DEVELOPMENT REVIEW COMMITTEE (DRC) COMMENT REPORT

PROJECT NAME: Victoria Park Townhomes

CASE NUMBER: UDP-S21037

REQUEST: Site Plan Level II Review: 10-Unit Townhouse
Development

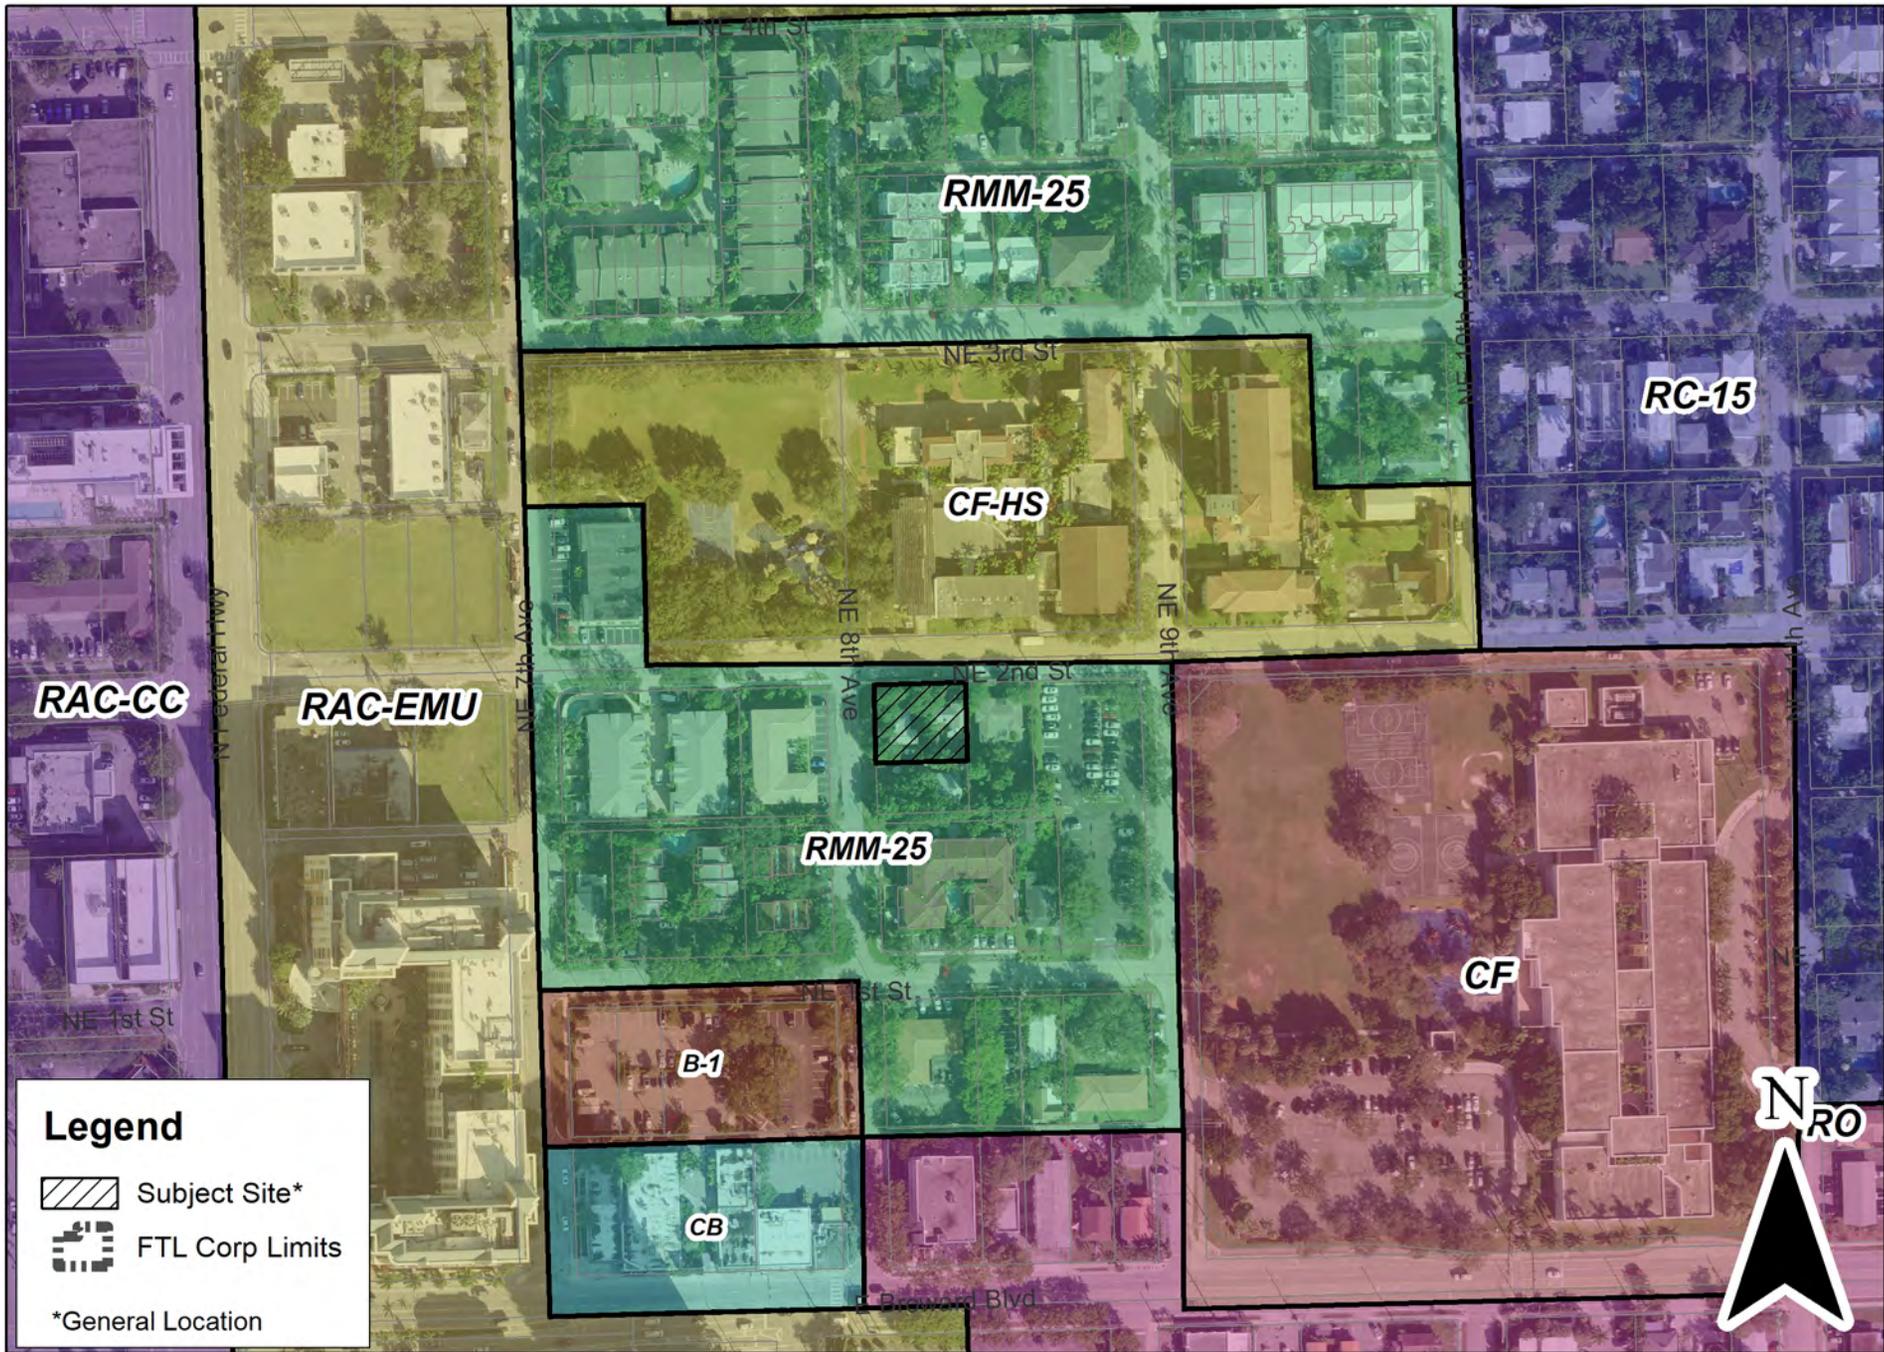
7. Provide the following changes on site plan:
 - a. Verify setback dimensions shown on the site plan;
 - b. Provide location of trash and recycle bins during the pick-up times;

- c. Provide 24-foot aisle between the provided guest spaces;
 - d. Orient Unit #812 to face the right-of-way, including the landing and sidewalk;
 - e. Ensure properly labeling of landscape materials on all sheets; and

- f. Provide dimensions from pool equipment to adjacent lot line.
 - g. Correct parking calculation in site plan data table.
